**Addendum No. 3**

**Final Environmental Impact Report  
for Metro Gold Line Foothill Extension - Azusa  
to Montclair (SCH 2010121069)**

**Evaluating Minor Design Changes of the Project  
Azusa to Montclair**

Metro Gold Line Foothill Extension Construction Authority  
March 2016

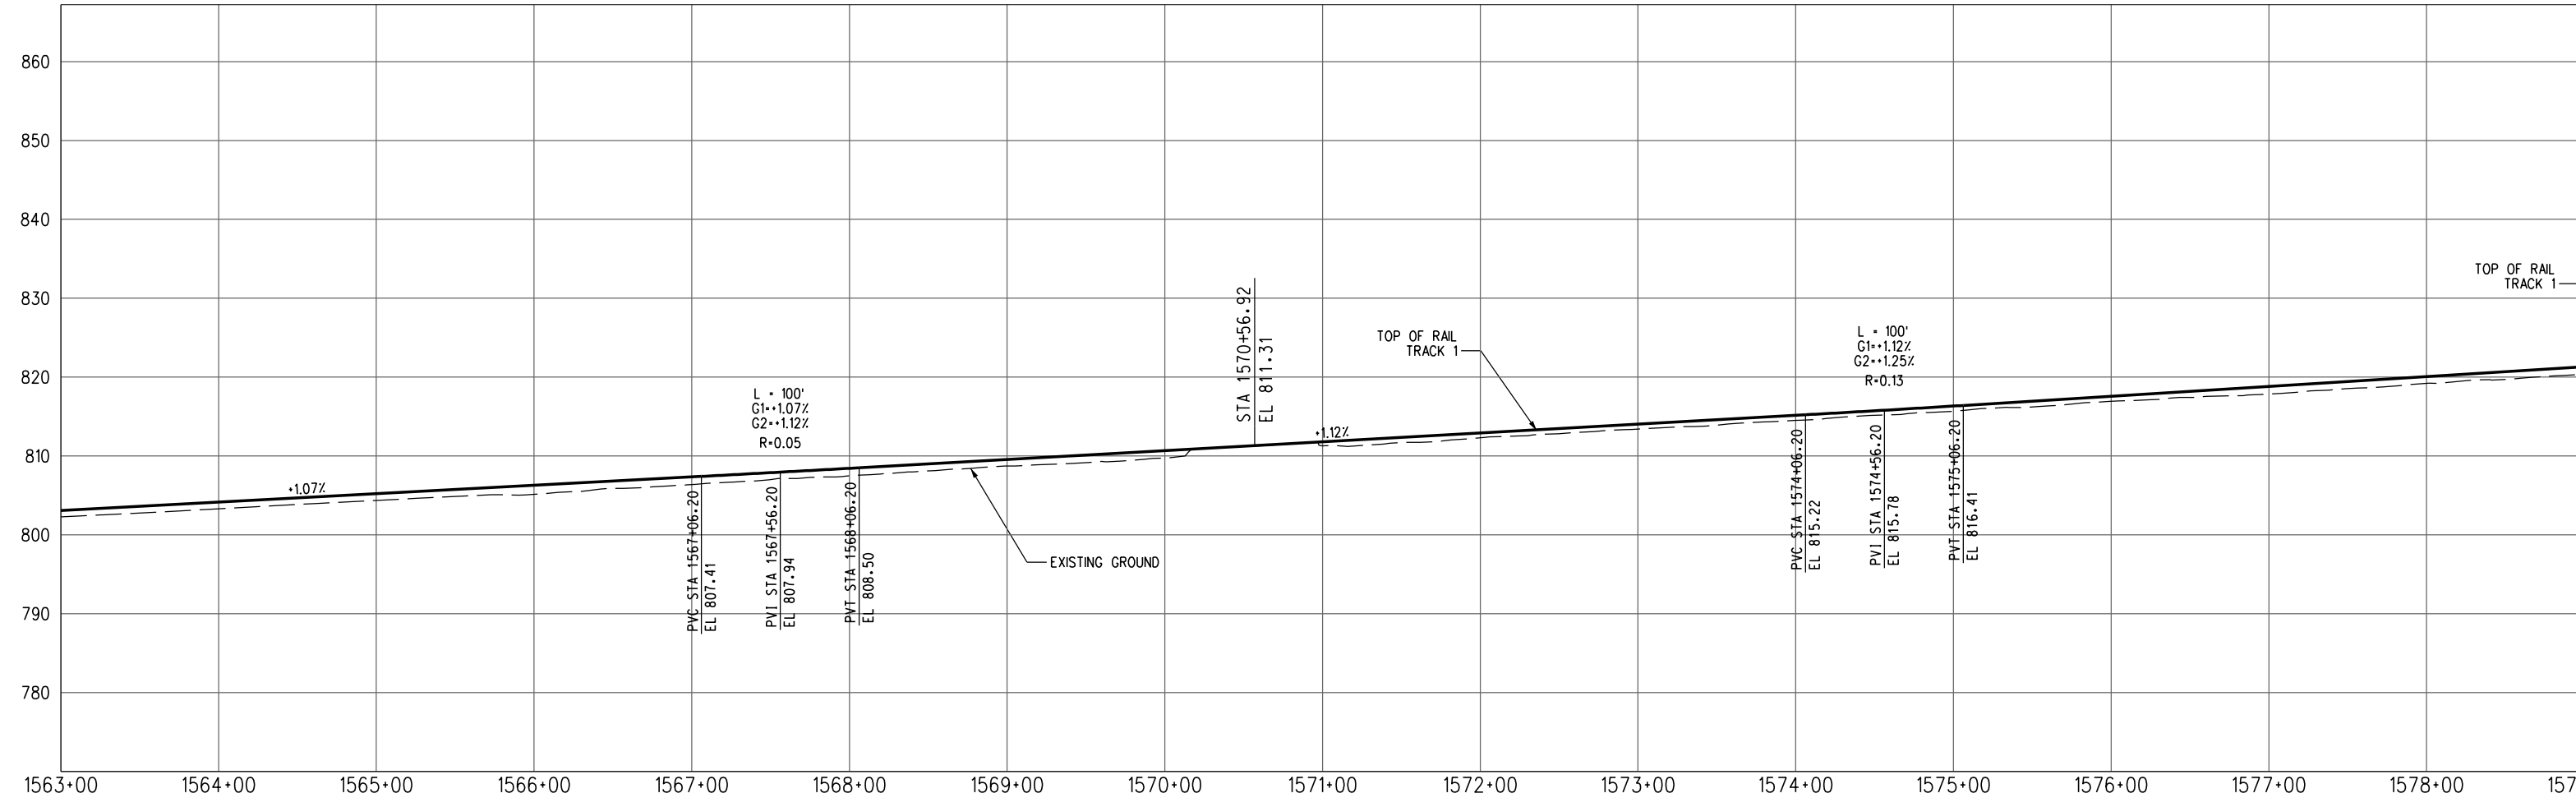
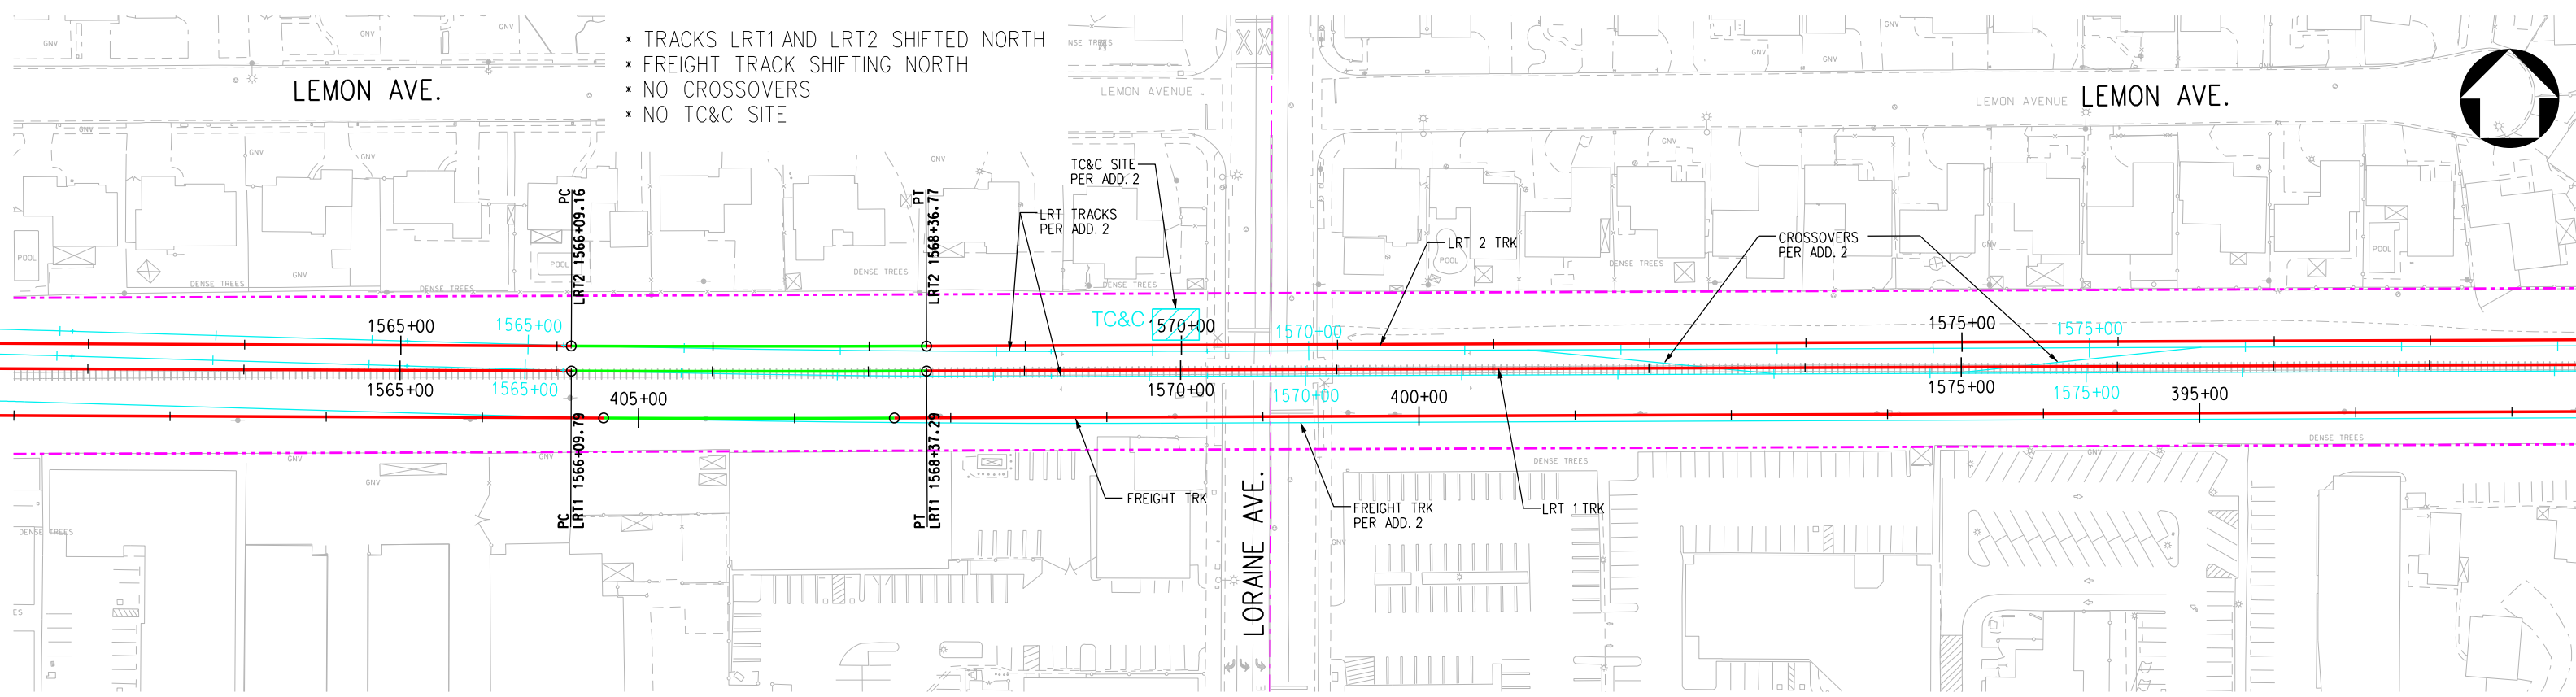
- × TRACKS LRT1 AND LRT2 SHIFTED NORTH
- × FREIGHT TRACK SHIFTING NORTH
- × NO CROSSOVERS
- × NO TC&C SITE
